Project	IEEE 802.16 Broadband Wireless Access Working Group < http://ieee802.org/16 >	
Title	Proposed Revision to Section B.3 (SC PHY Link Budget Analysis)	
Date Submitted	2002-01-16	
Source(s)	Anader Benyamin-Seeyar Harris Corporation Inc. 3 Hotel de Ville Dollard-des-Ormeaux, Quebec, Canada, H9B 3G4	Voice: (514) 845-8850 Fax: (514) 871-4859 mailto: abenyami@harris.com
Re:	Proposal to revise Section B.3 of document IEEE P802.16a/D1-2001 with provided text.	
Abstract	The Link budget given in Tables 265 and 266 are being revised in Section B.3 of document IEEE P802.16a/D1-2001. This contribution simplifies and provides more accurate and comprehensive link budget results.	
Purpose	Incorporate provided text as revision of Section B.3 of document IEEE P802.16a/D1-2001.	
Notice	This document has been prepared to assist IEEE 802.16. It is offered as a basis for discussion and is not binding on the contributing individual(s) or organization(s). The material in this document is subject to change in form and content after further study. The contributor(s) reserve(s) the right to add, amend or withdraw material contained herein.

Revision of SC PHY Link Budget Analysis

B.3: SC PHY LINK Budg

Figure 248a Path Loss Model for 30 m Base Station antenna height.

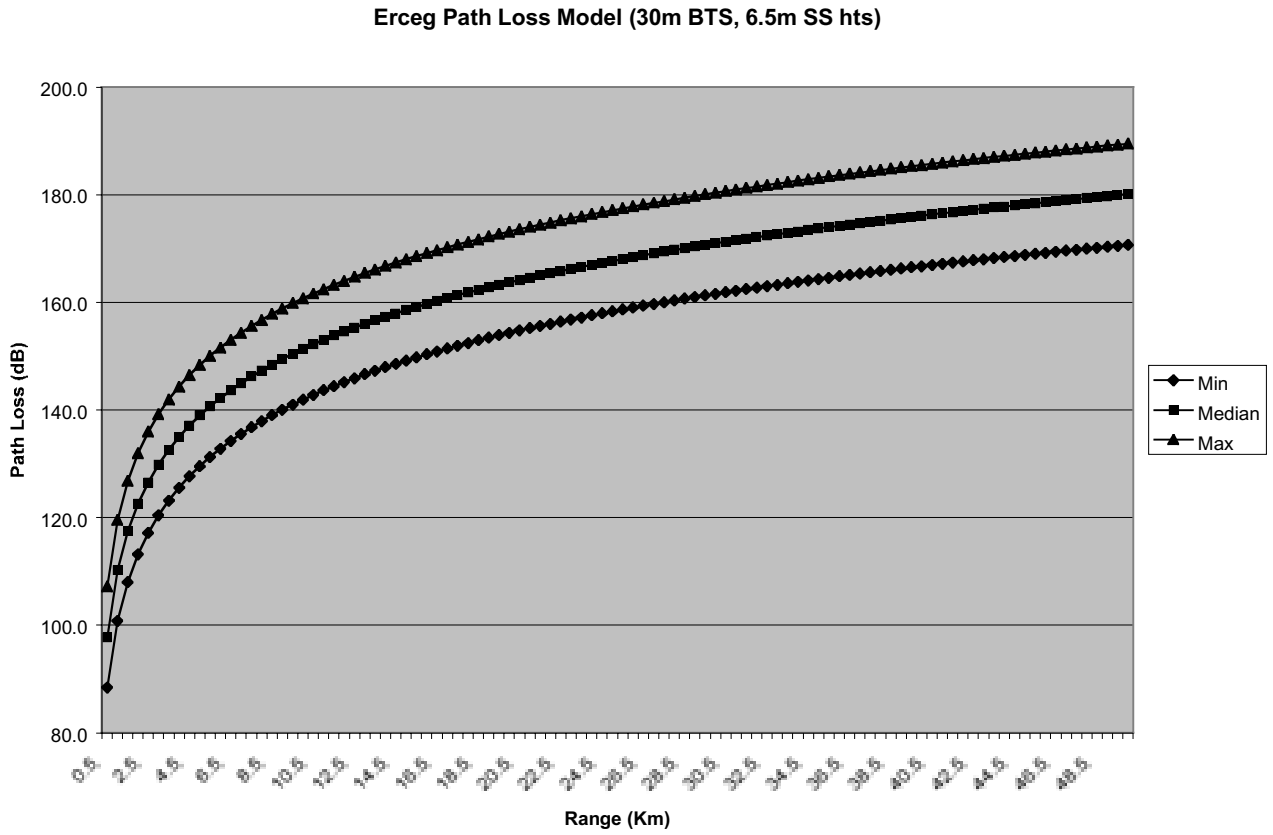
A complete link budget analysis was performed by combining various channel bandwidths and QAM constellations with the channel models found in [B64]. Two examples of the path loss versus propagation radius for Category C of the propagation model in [B64], assuming a 30 m and 80 m BS antenna and 6.5 m SS antenna, are shown in Figures 248a and 248b.
